AMENDMENT TO APPROVED MASTER PLAN APPLICATION

**Re: *Transportation Master Plan Amendment Summary Letter
McCoy Retreat Center
San Marcos, Texas***

McCoy's Retreat Center
TMP Amendment

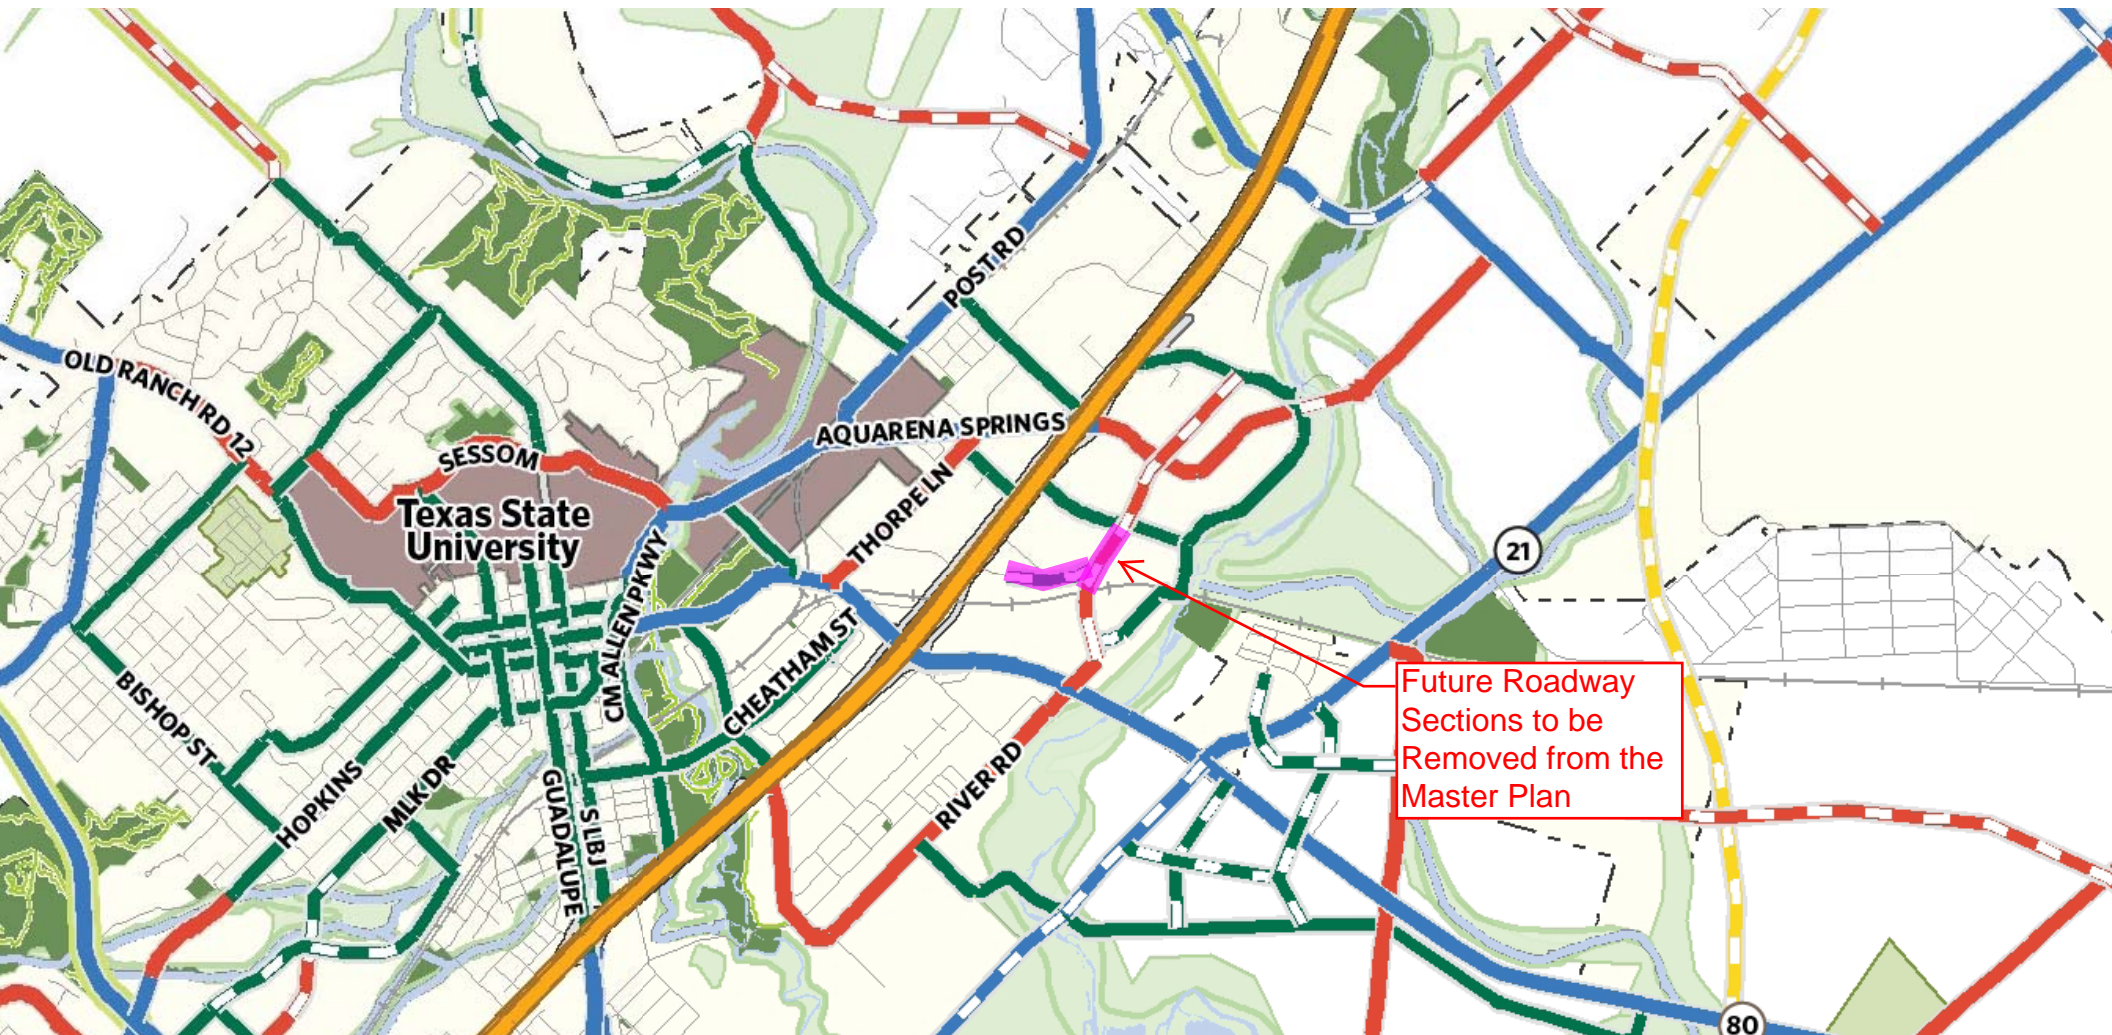
The TMP currently shows a Street extension through the heart of the site's oak groves that would connect McCoy Circle and the adjacent hotel development to Davis Lane. Additionally, the plan proposes a new Avenue that would run along the south side of the McCoy Office Subdivision Lot 2 connecting River Road to the south of the railroad to Davis Lane. The extension and locations of these proposed roadways would be in conflict with the intent of the proposed Retreat development. The new roads would further develop and pave over the natural landscape eliminating the private rural atmosphere of the subject

In summary, we respectfully request that the City amend the Transportation Master Plan to eliminate the proposed Street and Avenue extensions. Upon approval, our team will work closely with City Staff to comply with applicable codes and regulations for the subdivision and design of the project. If you should have any questions regarding this application or need additional information regarding the McCoy Retreat Center development, please feel free to contact us at 512-556-8160.

Future Roadway
Sections to be
Removed from the
Master Plan

Highlighted Section
to be Removed
from Plan
